Cty SF Rte 80 PM 13.4/13.8File # 20.25B**QUALITY ASSURANCE - NONCONFORMANCE REPORT****Location:** Trans Bay Steel (TBS) 1025 Kaiser Road Napa, CA**Date:** 10-30-2006**Prime Contractor:** Keiwit, FCI, Manson, (KFM)- Joint Venture**NCR #124****Submitting Contractor:** Trans Bay Steel (TBS)**Type of problem:****Welding** **Concrete** **Other** **Welding:** **Curing:** **Procedural:** **Bridge No.** 34-0006**Joint fit-up:** **Coating:** **Other:** **Component:** CIDH Steel Pile Casing T1-5**Procedural:** **Procedural:**

Contract No. 04-0120E4
04-SF-80-13.4, 13.8
SAS T1 & E2 Foundations
SFOBB-ESSSP

Subject: NCR - Trans Bay Steel, 10/30/06 (Girth Seam Alignment with Excessive Radial Offset)

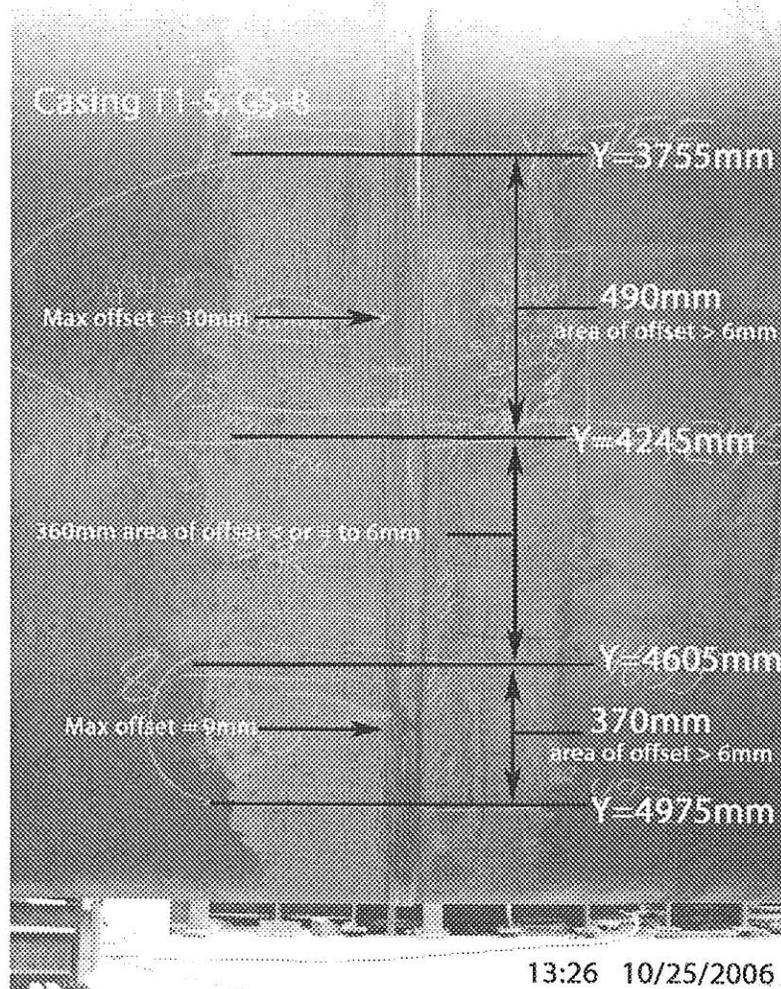
Description of Non-Conformance: Trans Bay Steel completed fabrication welding of the T1-5 steel pile casing girth seam No. 8 and the girth weld alignment (radial alignment) appears to be in excess of the maximum radial offset permitted by the contract documents.

Measurements were observed and recorded as follows: Two localized areas were identified with an offset in excess of 6mm; area #1 between "Y" locations 3755mm to 4245mm (490mm total length with a maximum radial offset measured to be 10mm) and area #2 between "Y" locations 4605mm and 4975mm (370mm total length with a maximum radial offset measured to be 9mm). An acceptable area of GS-8 with a total length of 360mm separated the two localized areas described above. See photo below. The contract documents allow one localized area with a maximum offset of 10mm provided the localized area is under 8T in length and filler metal should be added to provide a 4 to 1 transition. AWS D1.1 2002 allows the one localized area with the approval of the engineer and API Specification 2B contains the same language but does not require approval of the engineer.

On 10/25/06, after the offset of GS-8 was determined by the QA inspector to be in excess of the maximum radial offset permitted by the contract specifications, the TBS quality control manager Mr. Bill Kroplin and TBS general manager Mr. Bill Kavicky were notified verbally by the quality assurance area lead inspector and OSM representative Mr. James Cochran.

Contractor's proposal to correct the problem: On 10/25/06, TBS General Manager Mr. Bill Kavicky stated to the area lead Quality Assurance Inspector and OSM representative Mr. James Cochran, that TBS considers API specification 2B to be the applicable document. Mr. Kavicky stated that TBS does not need to submit an RFI to request approval of the engineer. Mr. Kavicky stated that TBS will remove 3mm of the base metal adjacent to the girth weld at area #2 which will bring the area #2 offset into compliance with the contract specifications. Mr. Kavicky stated that area #1 will then be in compliance with the 8T length requirement and will also be in compliance with API specification 2B.

The Department understands that the weld joining the members at girth seam No. 8 was transitioned at a 4:1 taper to adjust for the misalignment. This NCR is considered to be resolved and there is no further action required related to this issue. However, please take care to avoid such misalignment of girth seams in future work.

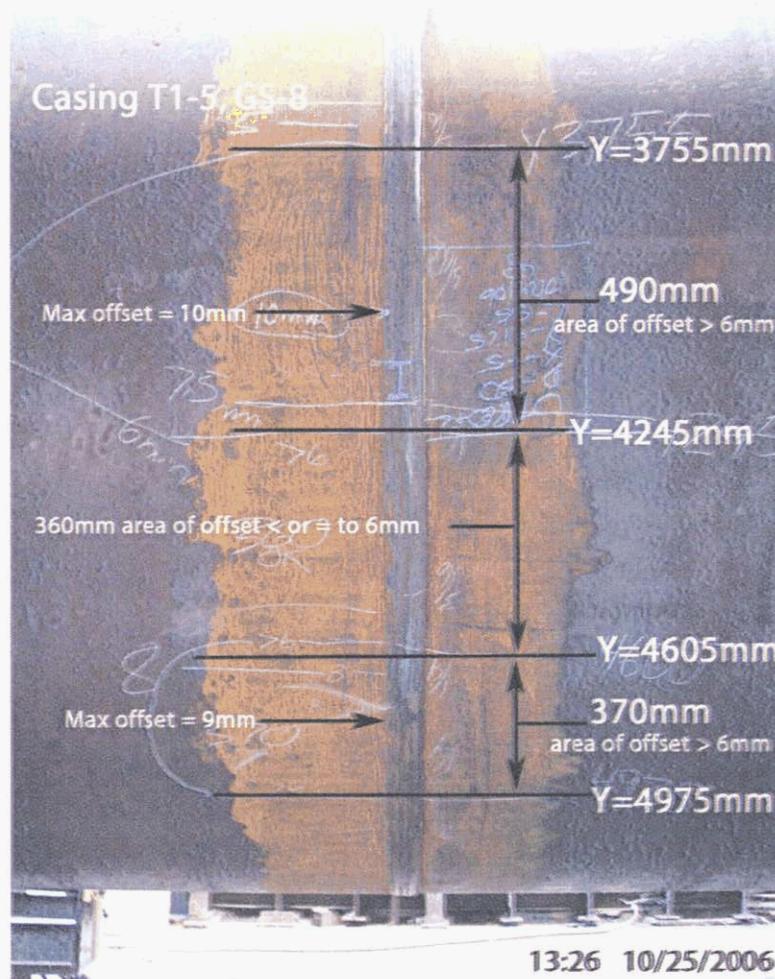
Contract # : 04-0120E4
Cty SF Rte 80 PM 13.4/13.8
File # 20.25B**QUALITY ASSURANCE - NONCONFORMANCE REPORT****Location:** Trans Bay Steel (TBS) 1025 Kaiser Road Napa, CA**Date:** 10-30-2006**Prime Contractor:** Keiwit, FCI, Manson, (KFM)- Joint Venture**NCR # (124)****Submitting Contractor:** Trans Bay Steel (TBS)**Type of problem:****Welding** **Concrete** **Other** **Welding:** **Curing:** **Procedural:** **Bridge No.** 34-0006**Joint fit-up:** **Coating:** **Other:** **Component:** CIDH Steel Pile Casing T1-5**Procedural:** **Procedural:** **Description of Non-Conformance:** Trans Bay Steel completed fabrication welding of the T1-5 steel pile casing girth seam No. 8 and the girth weld alignment (radial alignment) appears to be in excess of the maximum radial offset permitted by the contract documents.

Measurements were observed and recorded as follows: Two localized areas were identified with an offset in excess of 6mm; area #1 between "Y" locations 3755mm to 4245mm (490mm total length with a maximum radial offset measured to be 10mm) and area #2 between "Y" locations 4605mm and 4975mm (370mm total length with a maximum radial offset measured to be 9mm). An acceptable area of GS-8 with a total length of 360mm separated the two localized areas described above. See photo below. The contract documents allow one localized area with a maximum offset of 10mm provided the localized area is under 8T in length and filler metal should be added to provide a 4 to 1 transition. AWS D1.1 2002 allows the one localized area with the approval of the engineer and API Specification 2B contains the same language but does not require approval of the engineer.

On 10/25/06, after the offset of GS-8 was determined by the QA inspector to be in excess of the maximum radial offset permitted by the contract specifications, the TBS quality control manager Mr. Bill Kroplin and TBS general manager Mr. Bill Kavicky were notified verbally by the quality assurance area lead inspector and OSM representative Mr. James Cochran.

Contractor's proposal to correct the problem: On 10/25/06, TBS General Manager Mr. Bill Kavicky stated to the area lead Quality Assurance Inspector and OSM representative Mr. James Cochran, that TBS considers API specification 2B to be the applicable document. Mr. Kavicky stated that TBS does not need to submit an RFI to request approval of the engineer. Mr. Kavicky stated that TBS will remove 3mm of the base metal adjacent to the girth weld at area #2 which will bring the area #2 offset into compliance with the contract specifications. Mr. Kavicky stated that area #1 will then be in compliance with the 8T length requirement and will also be in compliance with API specification 2B.
